SERVICE BULLETIN: # SB-R01

AFFECTED PRODUCTS: CH77 Ranabot

SUBJECT: VERTICAL STABILIZER SUPPORT

Rear view up

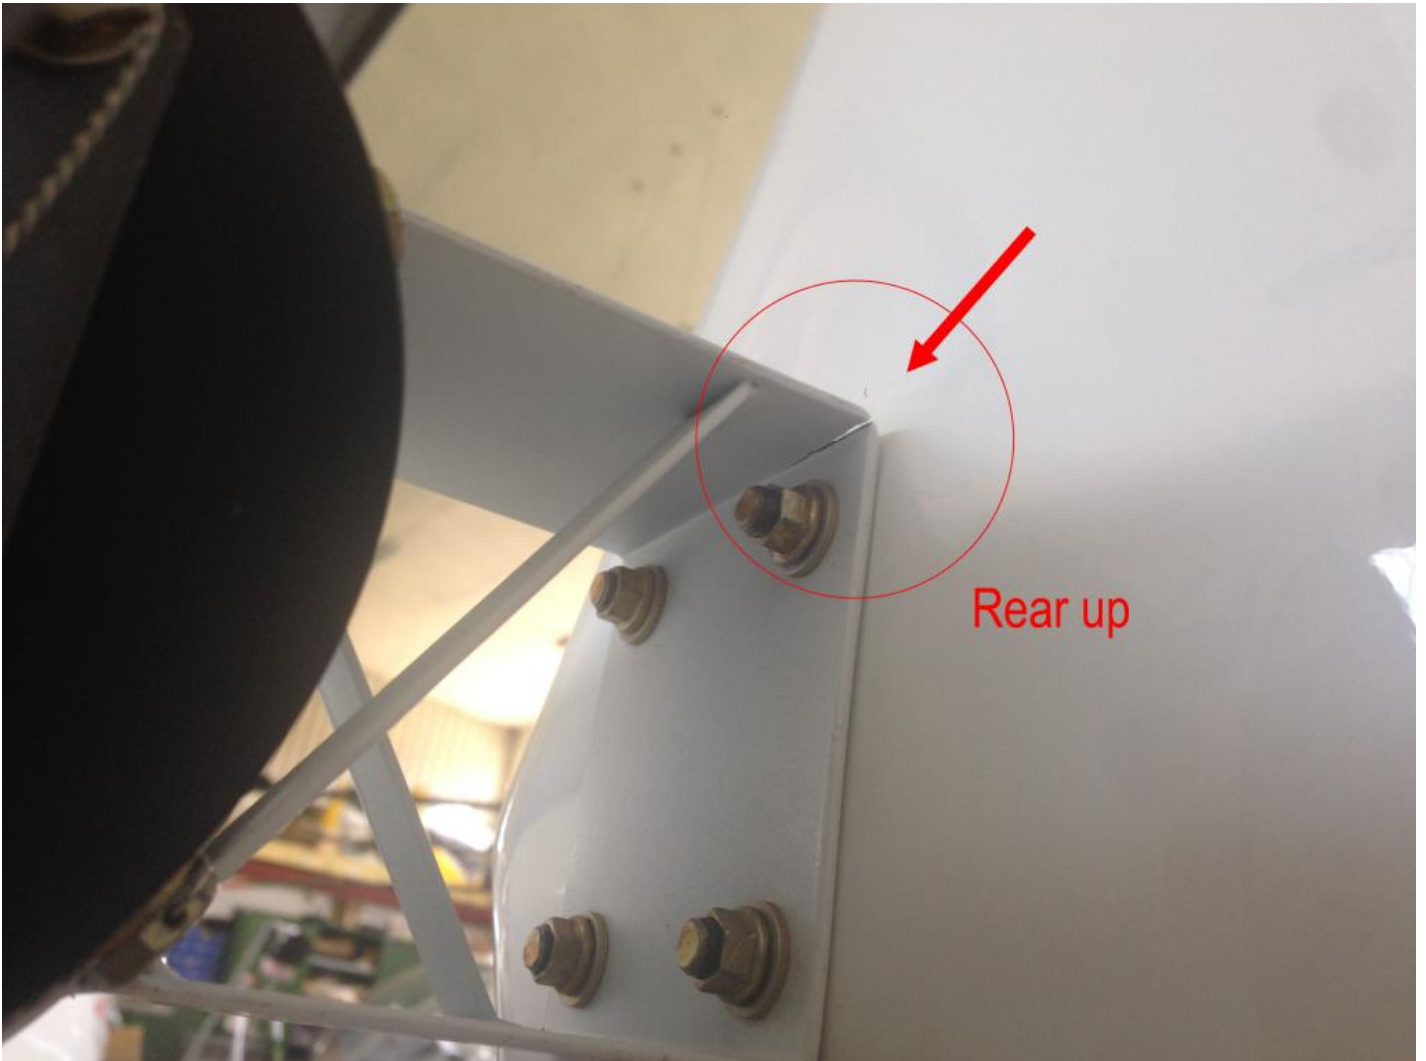
Inspect before the next flight the Vertical stabilizer support P/N CH7070200K in the areas under investigation to cracks of metal bending 90 degrees described in the attached photos . The Helisport Helicopters here will replace the part in exchange mode. Ship support to Helisport Helicopters to get the exchange.

REPLACEMENT: mandatory
